**TOWN OF LEESBURG
TOWN COUNCIL WORK SESSION**

Subject: Rezoning Application TLZM-2013-0006, Crescent Parke

Staff Contact: Michael Watkins, Senior Planner, Department of Planning and Zoning

Figure 3, Future Streets Policy Map

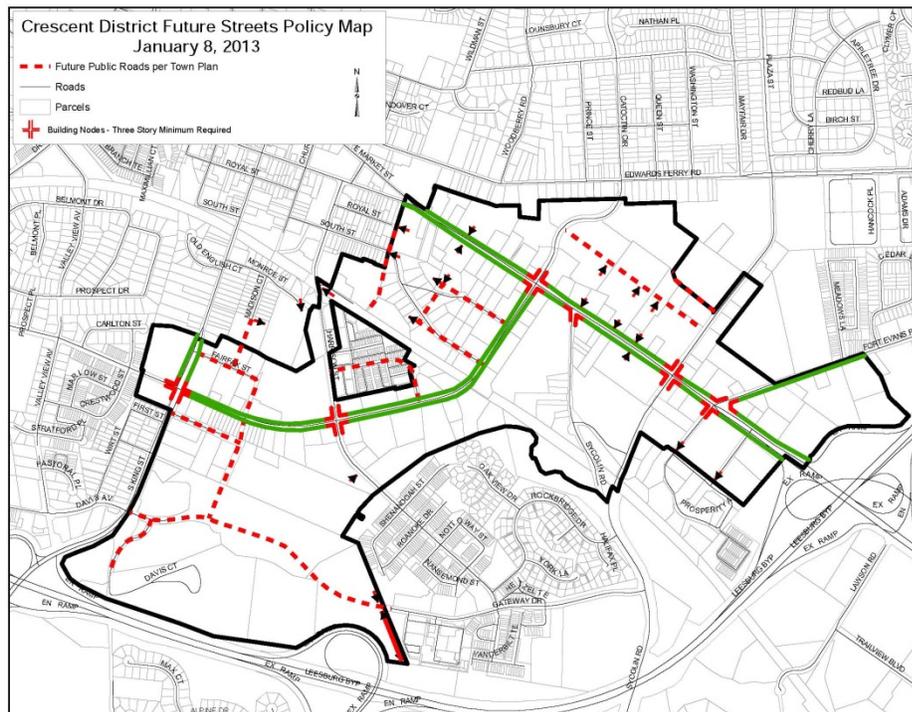
The Greenway Extension was not omitted from the Future Streets Policy Map. Moreover, connections points were included to provide flexibility in site design, potentially providing a more urban form of development.
